RFI #: 49
 Date: 2/3/2012
 Job: EB-02 Keller Springs Lofts
 Phone: 877-777-5115

Subject: thickened beam wall rebar requirements

RFI #: 59
 Date: 2/21/2012
 Job: EB-02 Keller Springs Lofts
 Phone: 877-777-5115

RFI #: 172
 Date: 7/11/2012
 Job: EB-02 Keller Springs Lofts
 Phone: 877-777-5115

Drawing: 8/SG3.02
 Cost Impact: None
 Spec Section:
 Schedule Impact: None

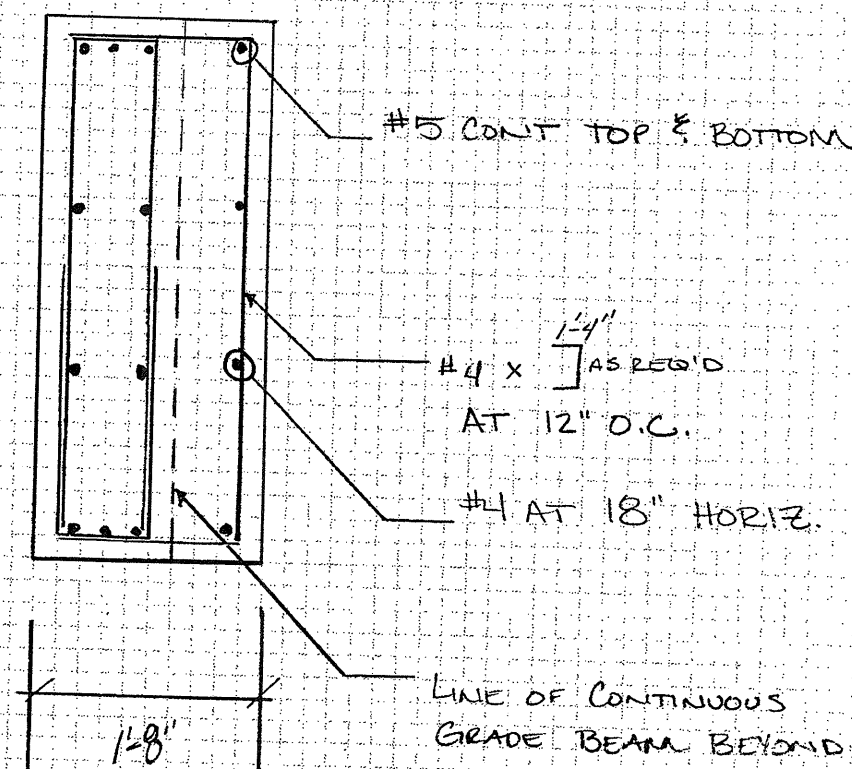
Request:
 East Texas Precast calls for a 5' x 5' x 3/8" angle iron per the attached detail. Please confirm that this is the size that you prefer.

EAST TEXAS PRECAST IS RESPONSIBLE FOR THE DESIGN OF THIS ITEM. PPO TAKES NO EXCEPTION

RFI # 49

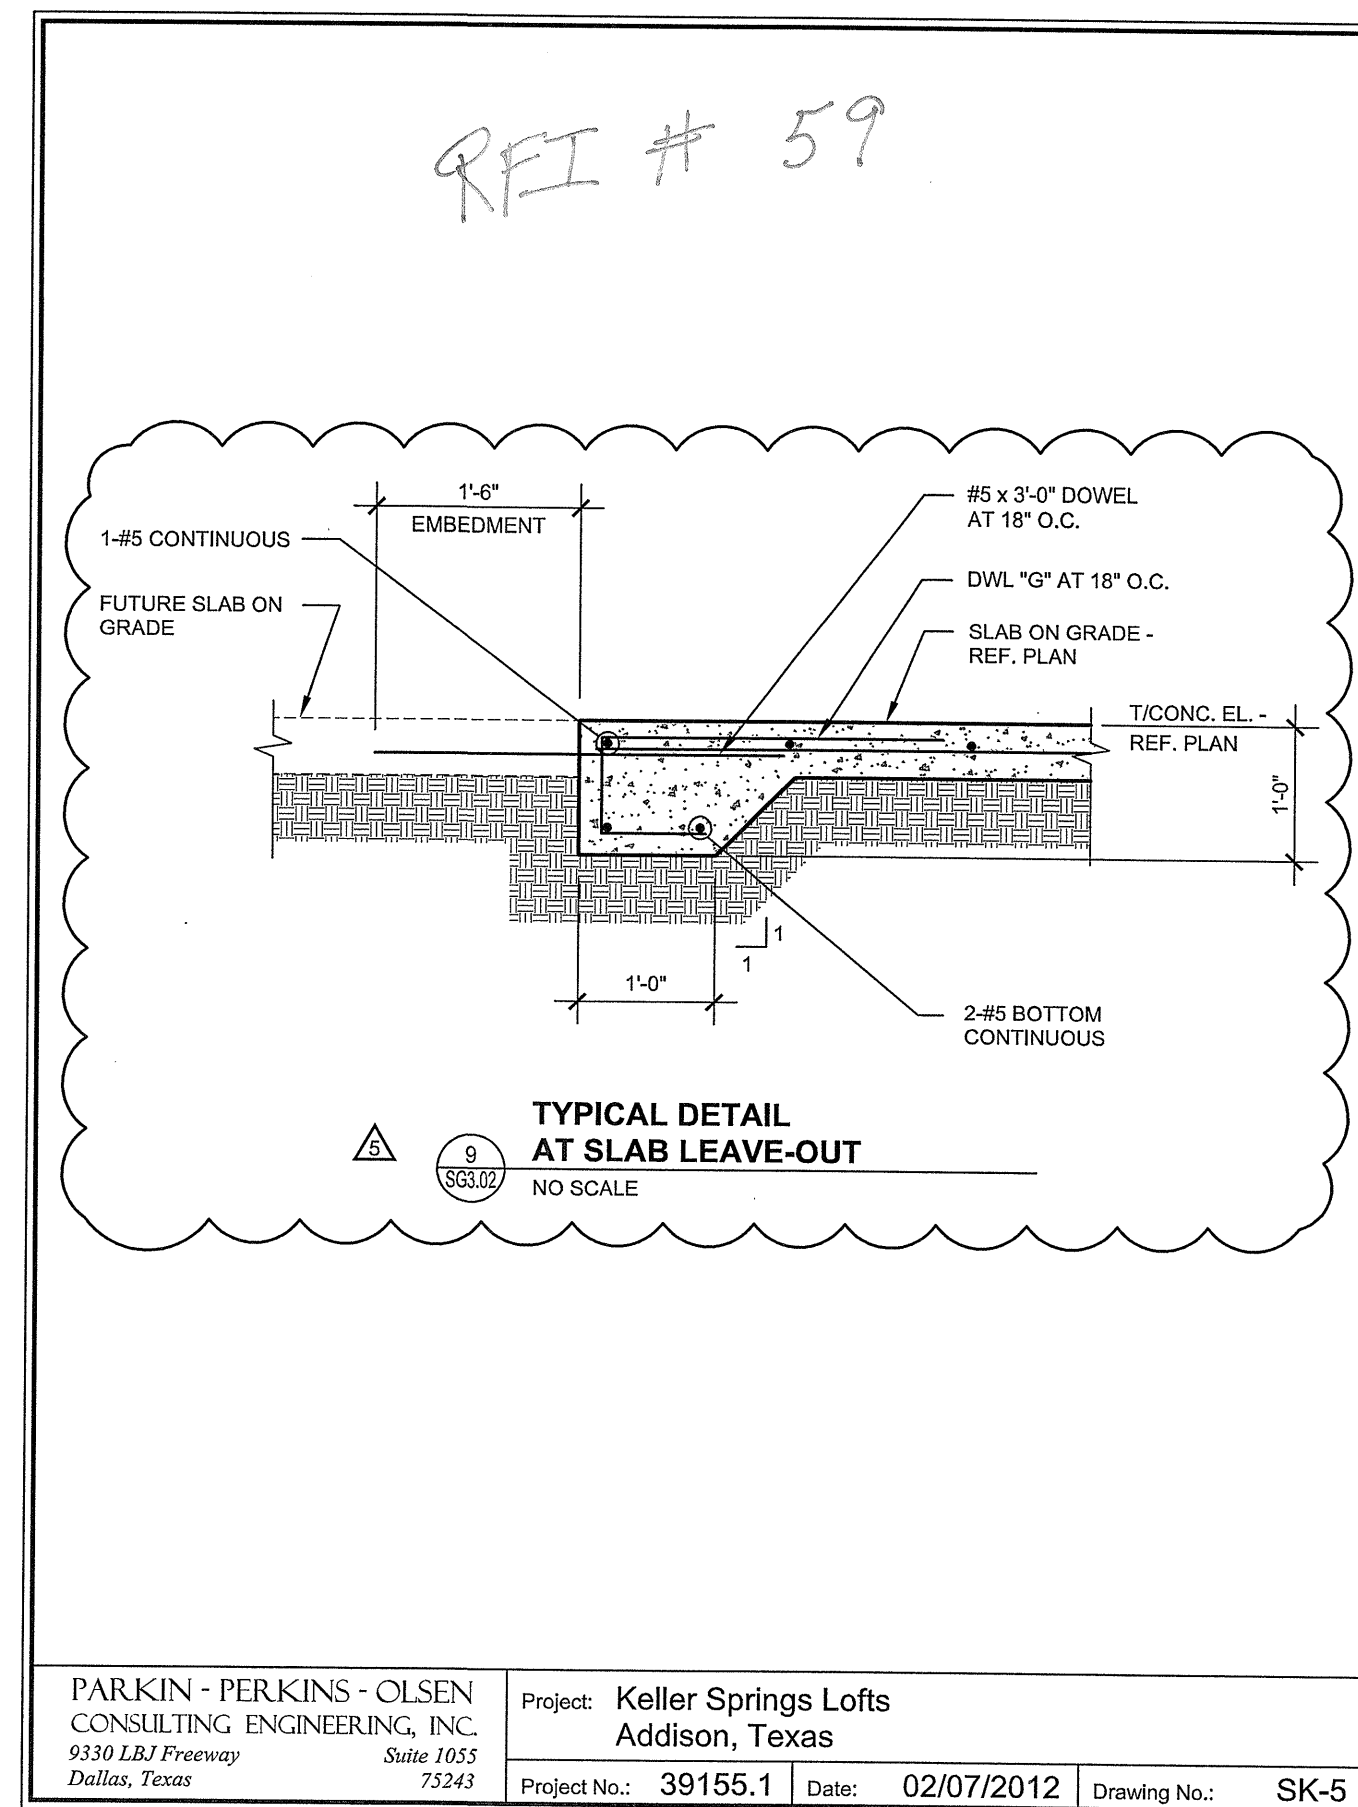
Request:
 At the intersection of Grid line 2 and Grid line B is a 6' section of thickened beam wall. 3/SG3.02 is the cut-thru of this wall, but does not show this thickened area for rebar requirements. Because of panel limitations we will have to make the width of the beam 16" instead of 16". Therefore, this thickened area of the wall will be 6'-0" X 16". Please advise and detail the proper steel reinforcing requirements see attachments.

Reference the attached detail for beam width and reinforcement detailing. If you have questions or require additional information regarding this matter, please do not hesitate to contact us.

NOTE: REF 3/303.02 FOR ADD'L INFO NOT SHOWN
